# C-400 90% Design Independent Technical Review Report and Implementation Plan

### FINAL IMPLEMENTATION PLAN C-400 INTERIM REMEDIAL ACTION 90% DESIGN DOE-HQ INDEPENDENT TECHNICAL REVIEW RECOMMENDATIONS

Figure 2. TCE source material in the vicinity of Building C-400

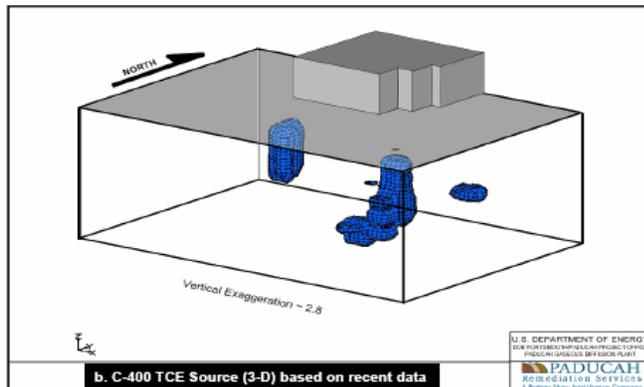
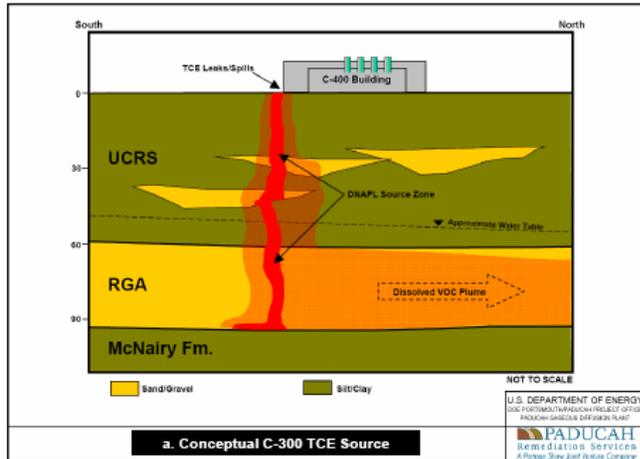
- Conceptual model shows released TCE migrating through soil (UCRS) down into aquifer (RGA).
- Area of higher concentration (DNAPL) delineated by use of “MIP” (Membrane Interface Probe).
- Report recommends:
  - Revisiting the data interpretation to ensure entire source area is treated.
  - collecting additional samples during installation of equipment to verify MIP results.
  - installing monitoring wells downgradient of treatment area as part of the action.

Figure 9. Idealized heating profile for a simple saturated system containing TCE DNAPL and water

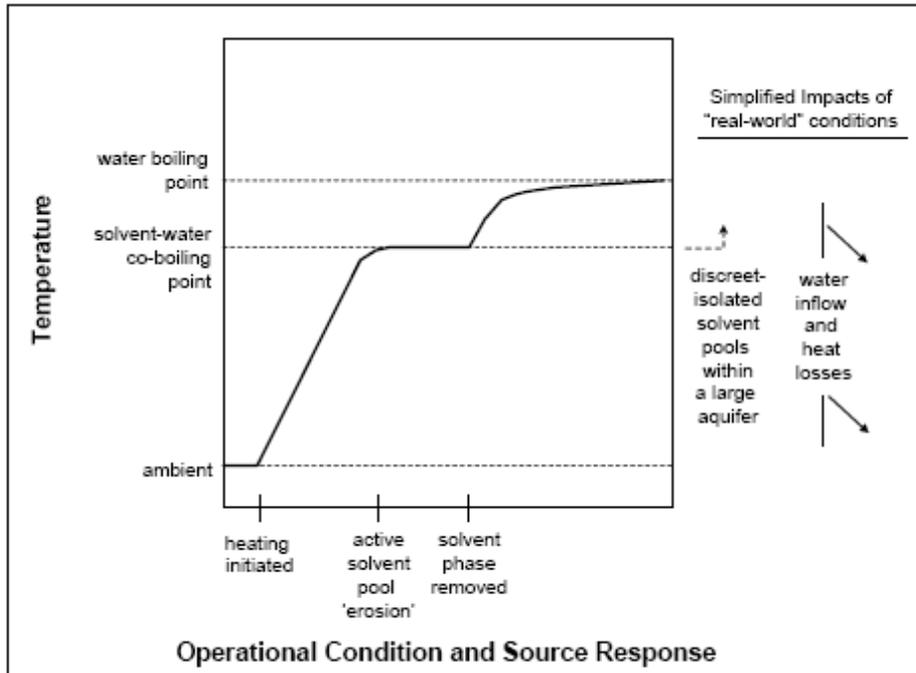
Primary recommendation is to work with regulators to define “asymptosis” in the final Design Report to ensure “asymptosis” is appropriately linked to:

- target temperature.
- removal of maximum amount of TCE mass.
- cost effectiveness of removal.

Figure 10. Simplified schematic of convection processes during ERH of the permeable portion of the treatment zone

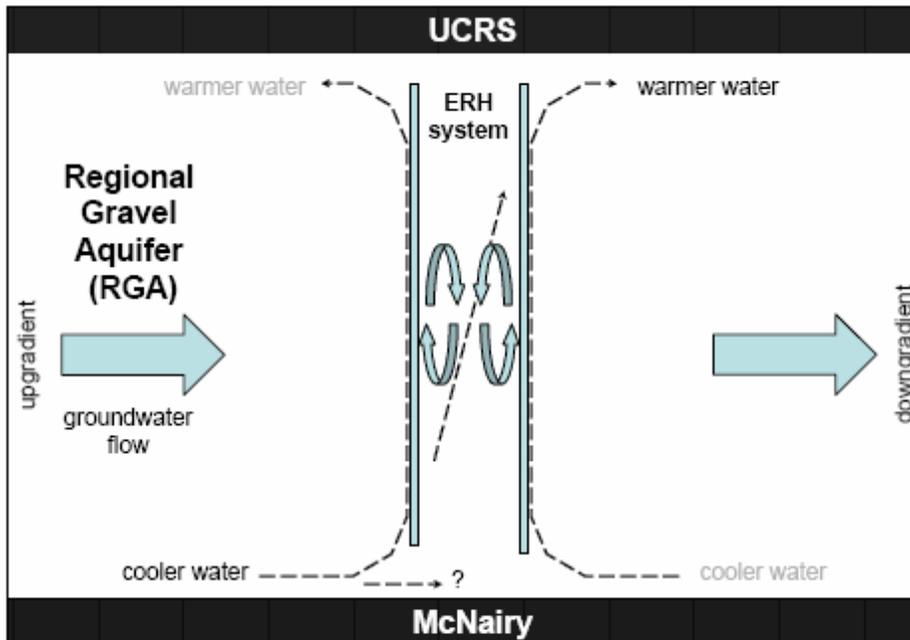
- Primary concern is uncertainty in the ability of ERH to heat effectively the TCE source area at the bottom of the RGA.
- Technology is complex. Use phased implementation to reduce uncertainties in electrode array design and improve chance of success.
